**TECHNICAL SYSTEMS AUDIT
OF THE
ALLEGHENY COUNTY HEALTH DEPARTMENT
2019**

Conducted by US EPA Region 3
Air & Radiation Division
Air Quality Analysis Branch

October 2019

Finding FSE-8: Instrument serial numbers not visible or accessible

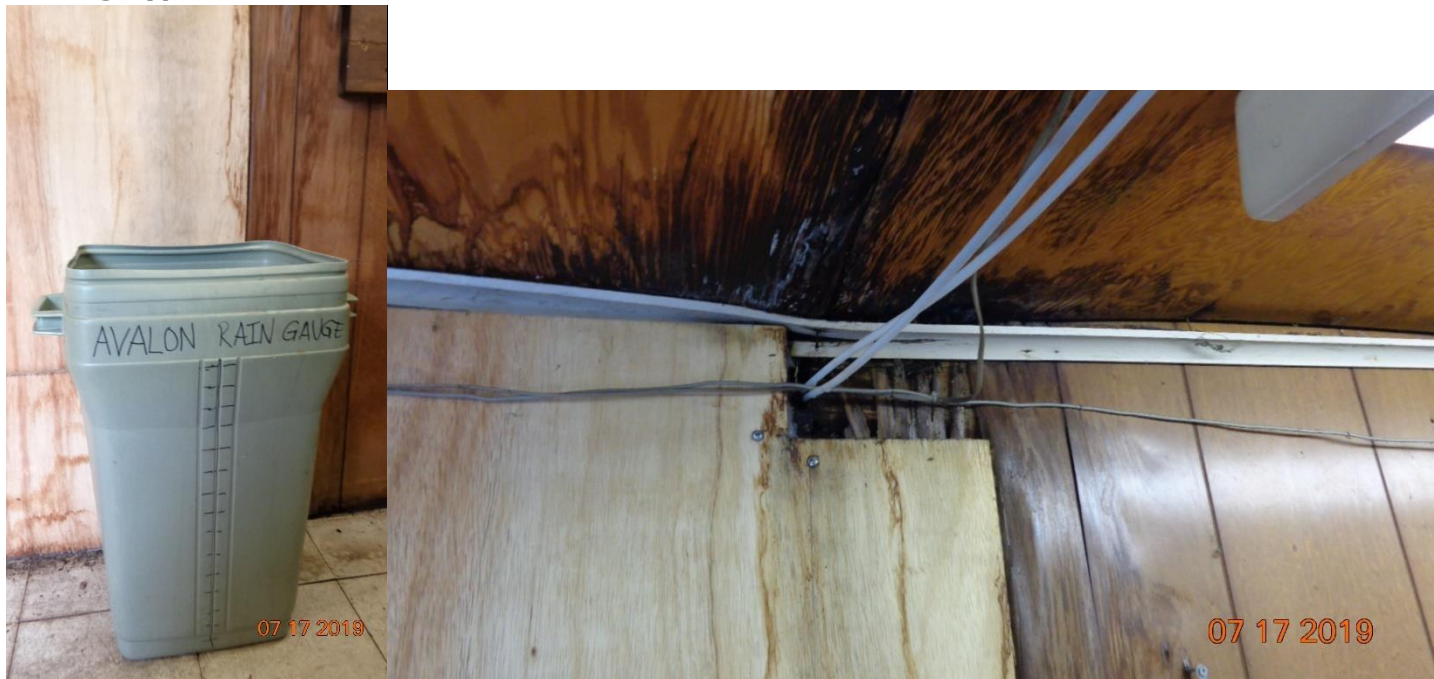
Discussion: At multiple sites, R3 auditors were unable to access instrument serial numbers. In some cases, the instrument serial number was written on the face of the instrument, but log books contained a different serial number for the same instrument. There appeared to be two different ways of referring to the instruments 1) a serial number assigned by ACHD, 2) the instrument manufacturer serial number. EPA R3 records instrument serial numbers on audits to be able to easily refer to specific instruments and track instruments in log books.

Recommendation/Corrective Action: Standardize the instrument serial numbers used to refer to specific instruments in log books and other records (either manufacturer or ACHD number). For instruments where serial numbers cannot easily be accessed, write or place a sticker on the front of the instrument legibly displaying the serial number.

ACHD Response: *Will implement SOPS to use only instrument serial numbers (not asset tag numbers).*
